PLANNING & ZONING BOARD AGENDA

**PLANNING & ZONING BOARD
AGENDA ITEM 7A**

The applicant, Charles Cudd Co, submitted a Land Use Application for PUD Amendment #1. They are requesting an amendment to the PUD Preliminary Plan/Preliminary Plat ("PUD Amendment #1") to construct 13 single-family lots west of Wilkinson Way instead of the approved 20 townhomes lots.

SHEET
A0-12

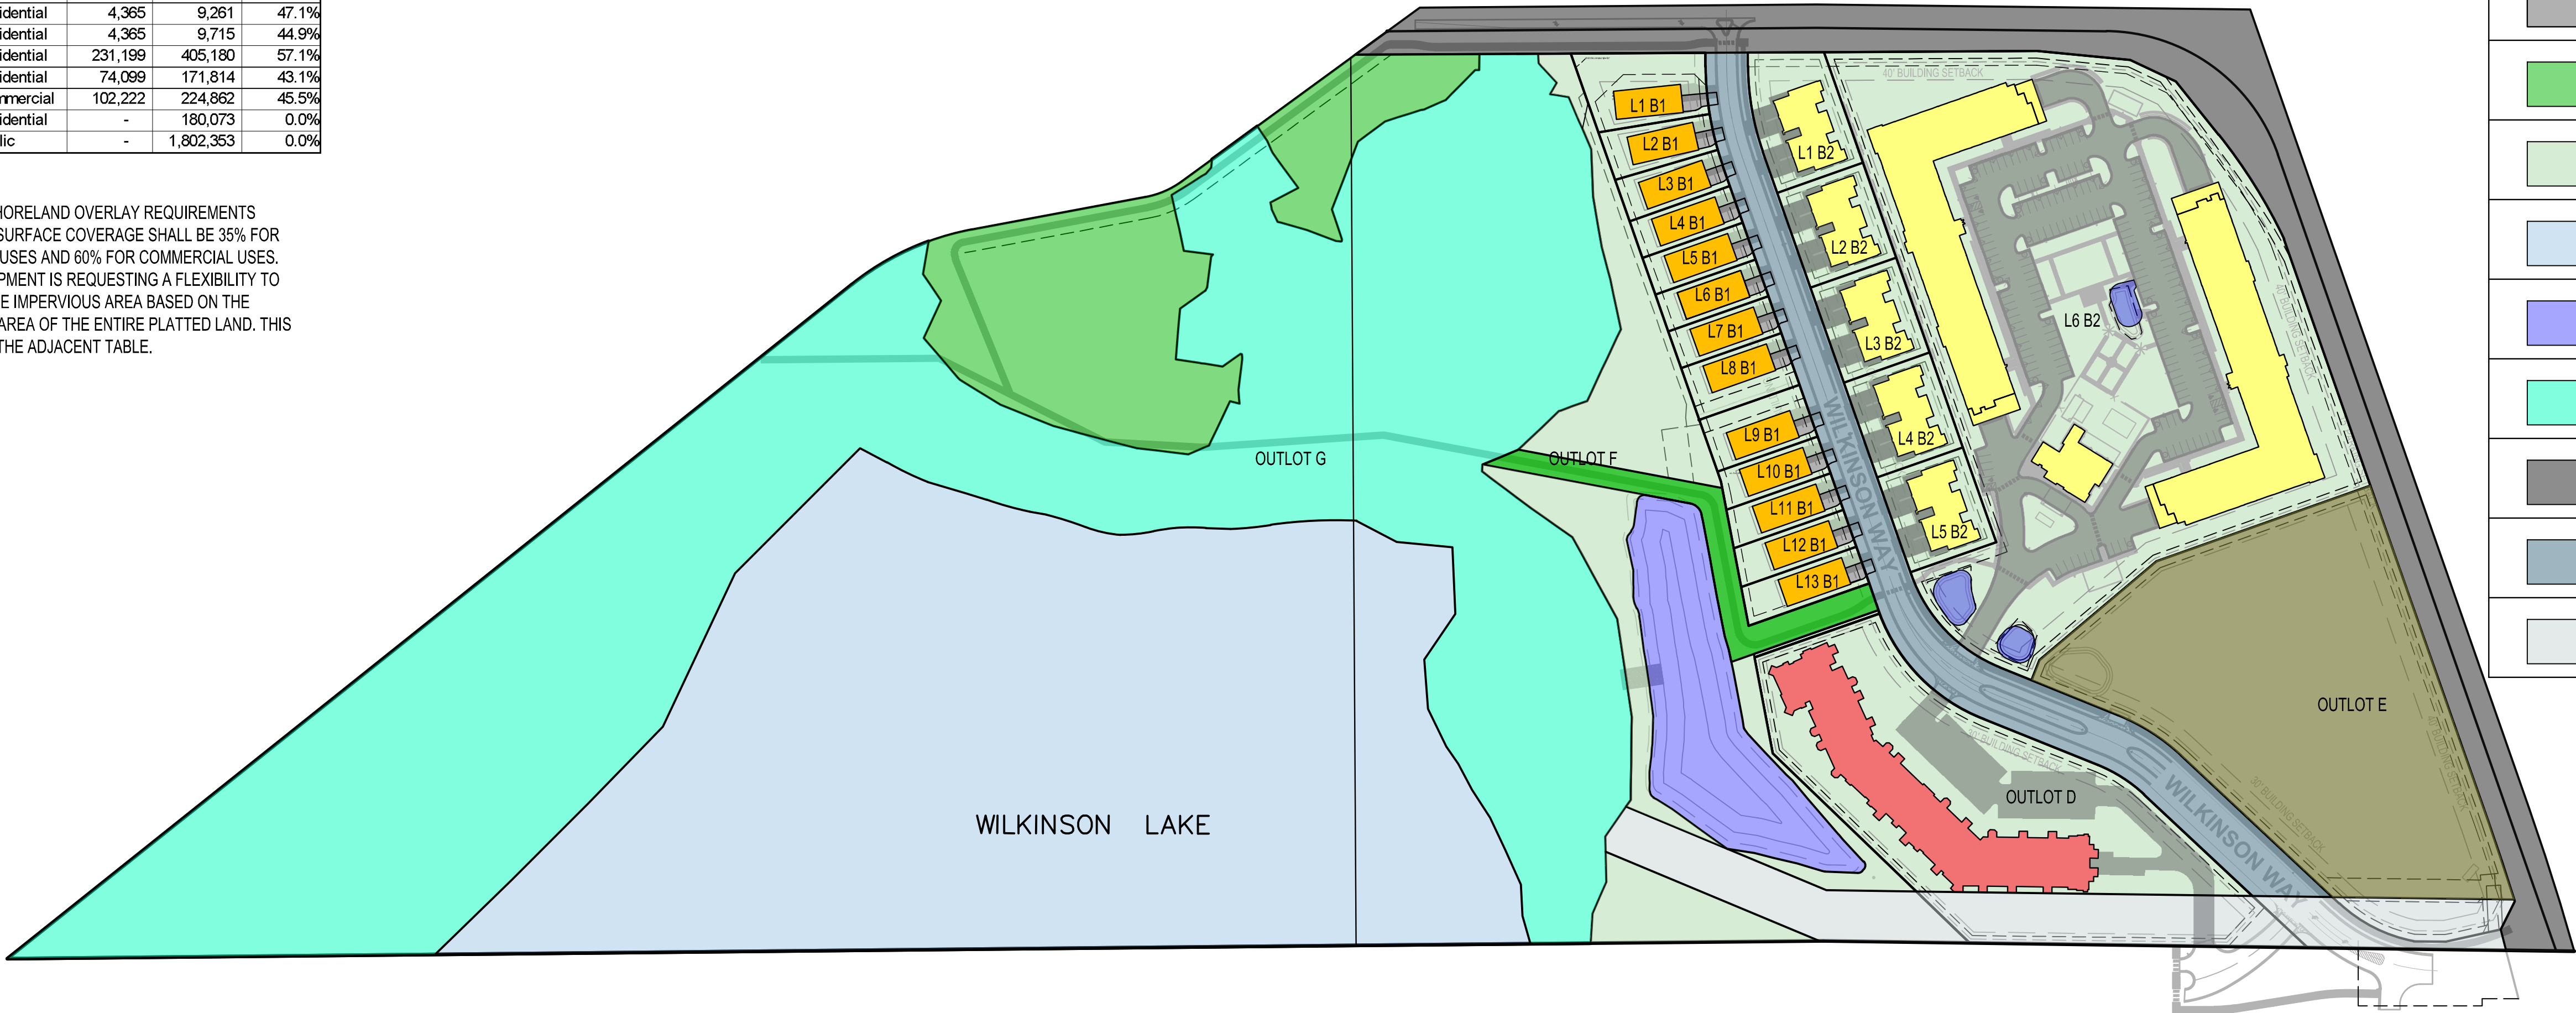
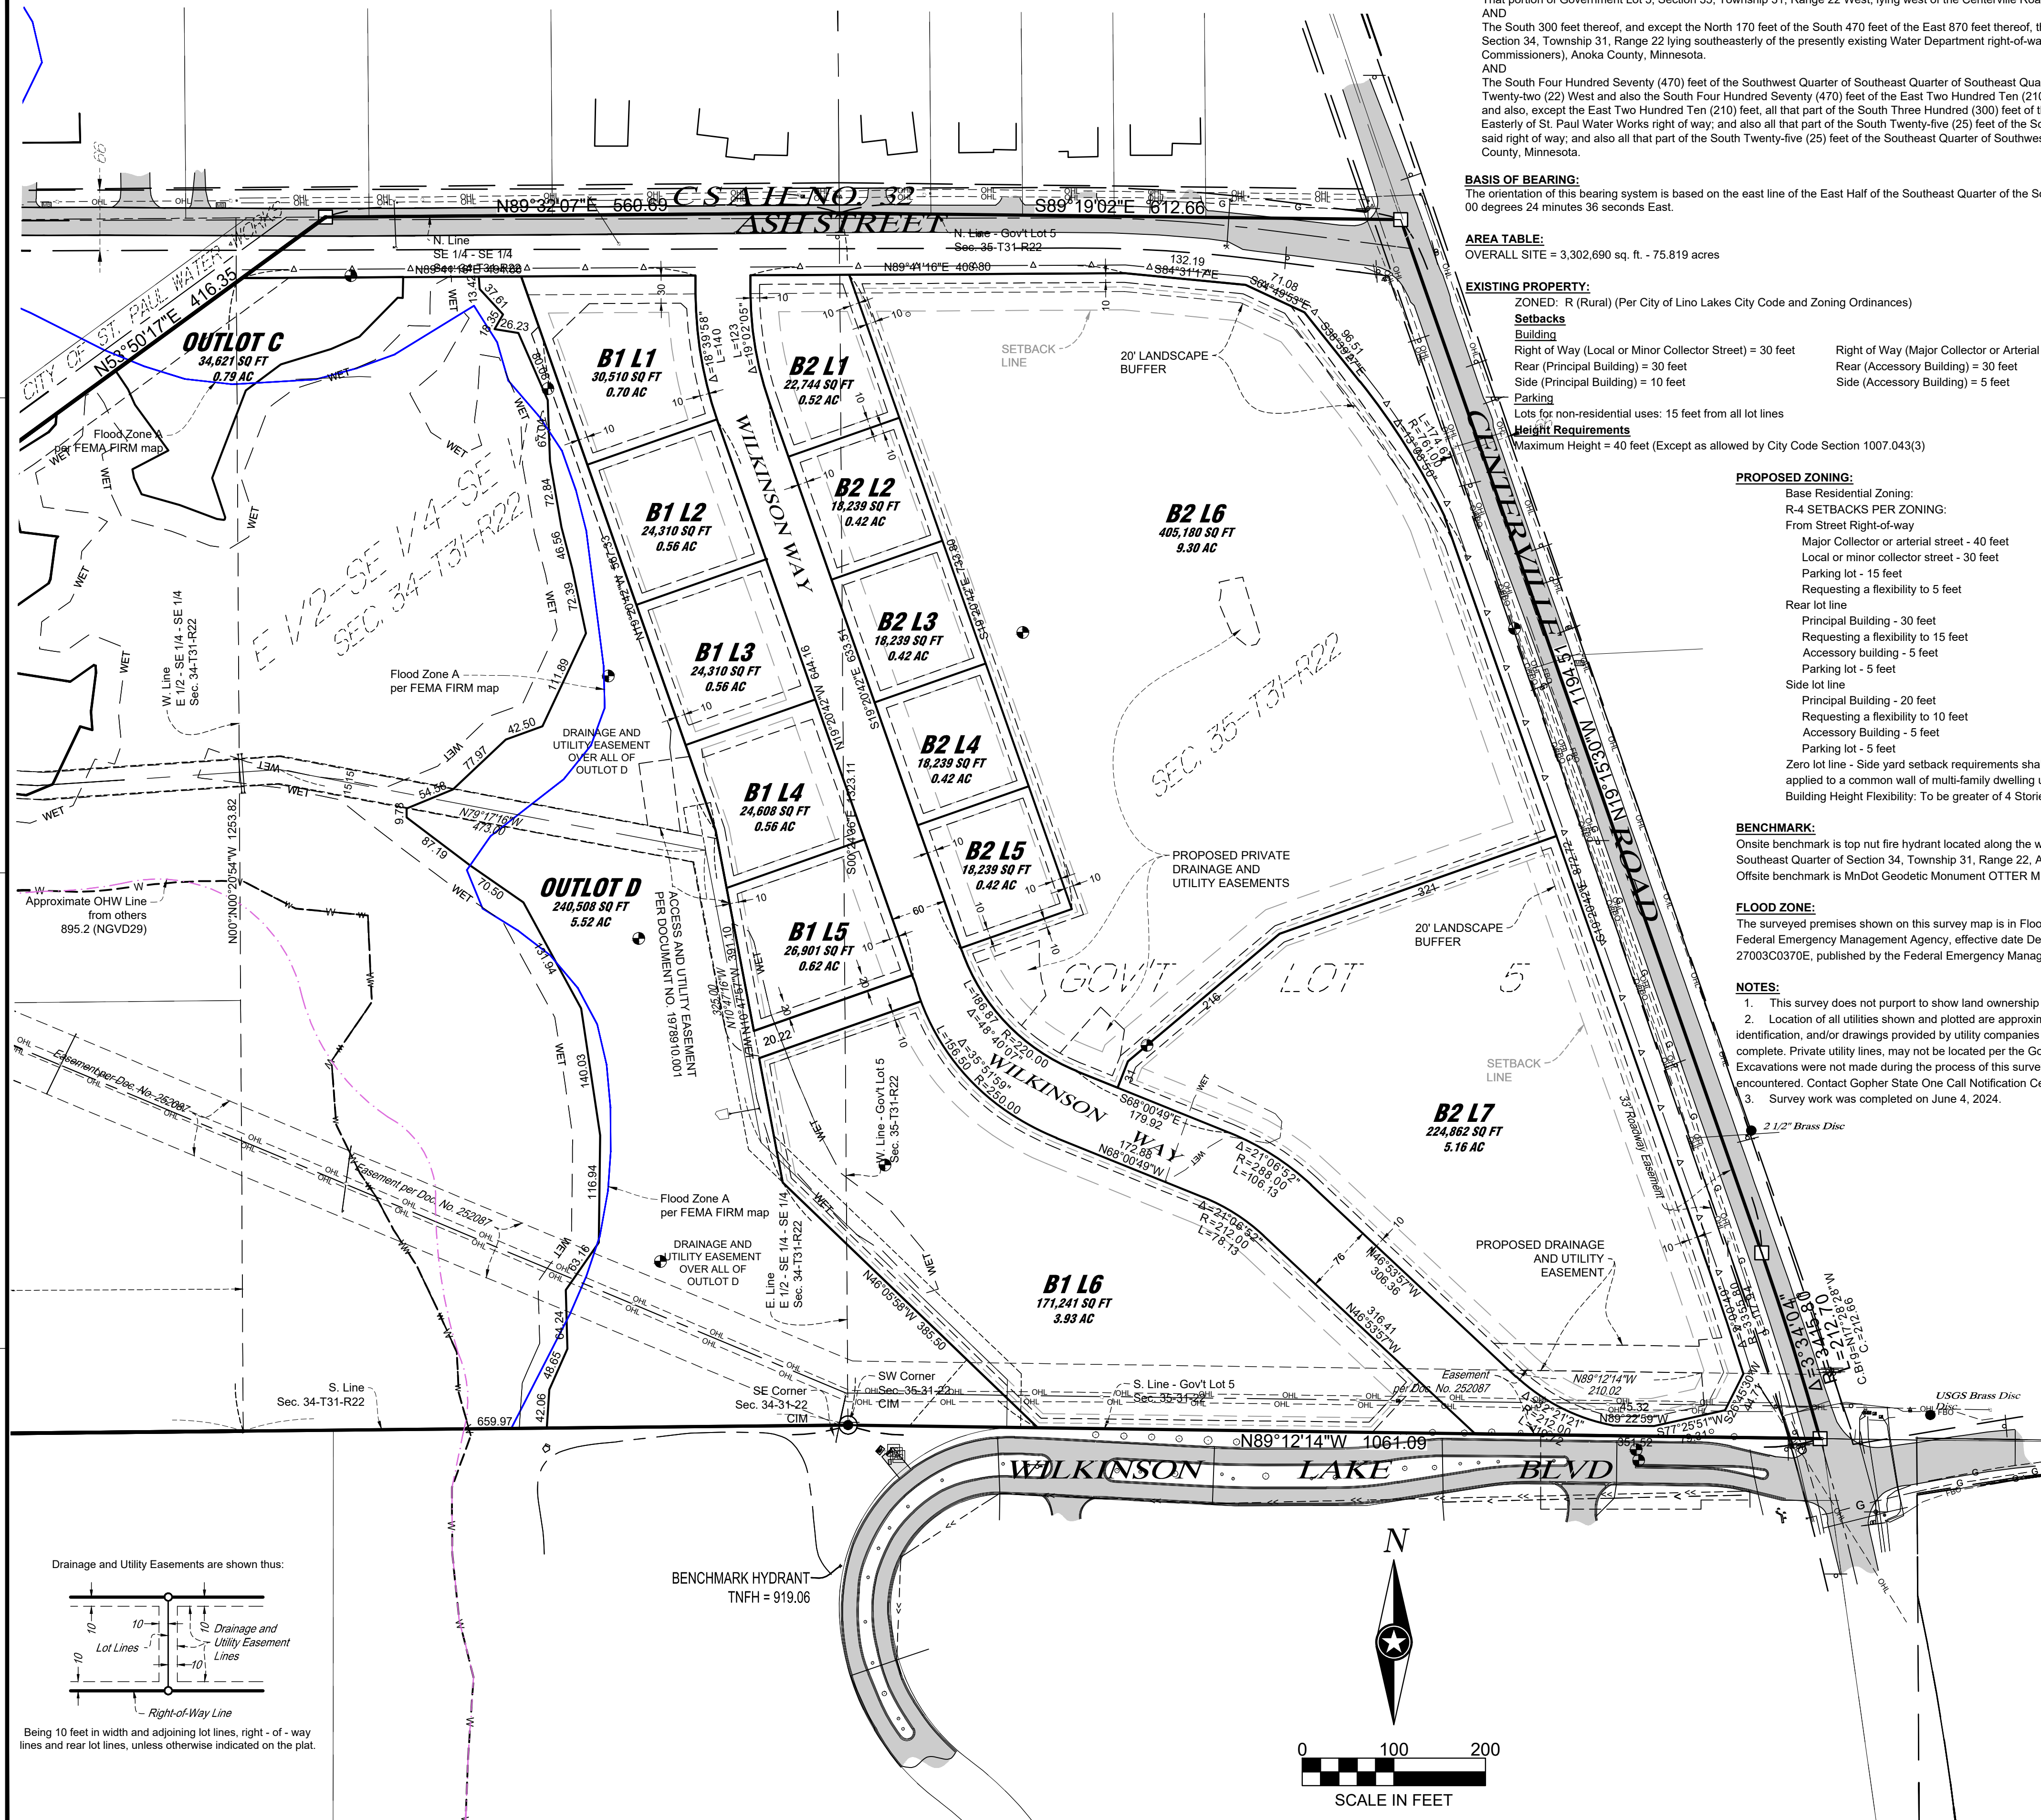
The subject property is located within the Shoreland Management Overlay District of both Wilkinson Lake and Amelia Lake. Maximum allowed townhome impervious coverage is 35% and commercial/multi-family is 60%. Per Sheet A0-12, Land Use & Density Plan, the overall development's total aggregate impervious coverage is 24.6%, which is less than the minimum 35% allowed.

TITLE
PRELIMINARY PLAT
SHEET
A0-16

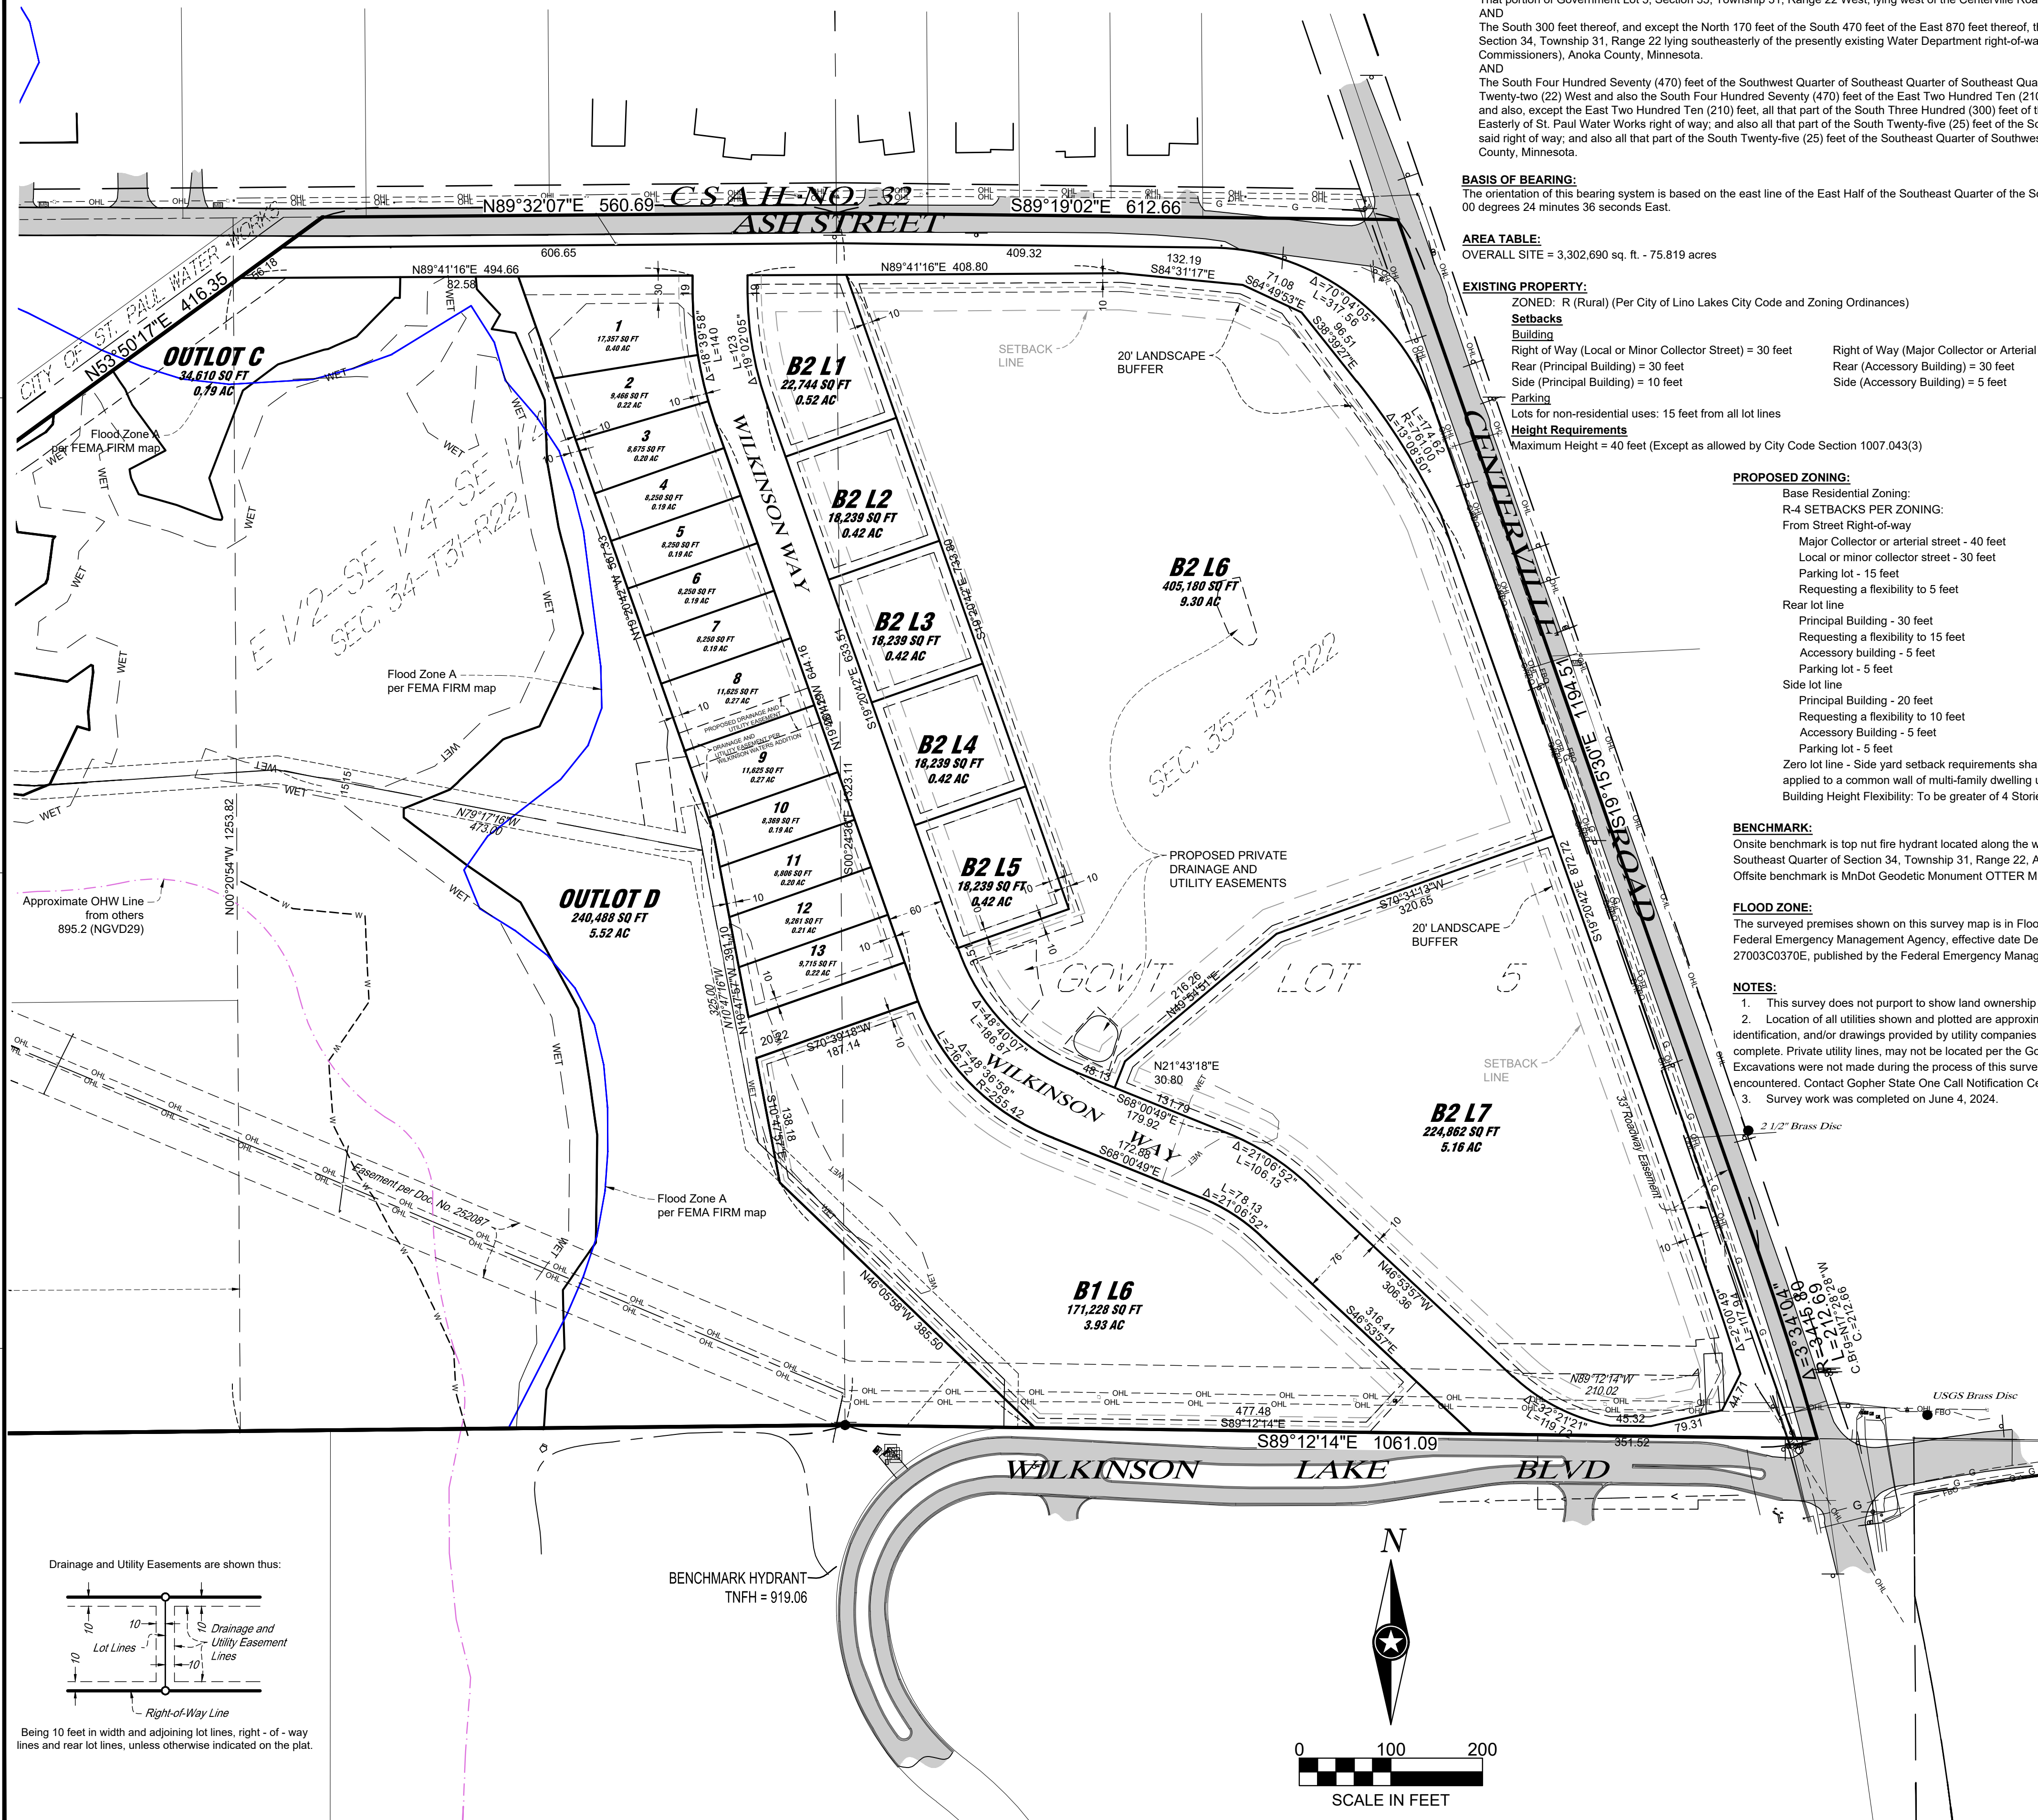
- a. Revision Schedule dates shall continue after latest version dated 11/3/25 and the description shall be PUD Amend #1 (13 SF lots).
- 5. Sheet A0-17, Preliminary Plat:

- a. Block number shall be added to Block 1.
 - b. Show lot widths and lot depths.
 - c. Drainage and utility easements shall be shown on all lot lines.

- d. Add information under Proposed Zoning for R-2 requirements.
- 6. All plan sheets for Charles Cudd Co architecture plans:
 - a. Plans shall be to scale.
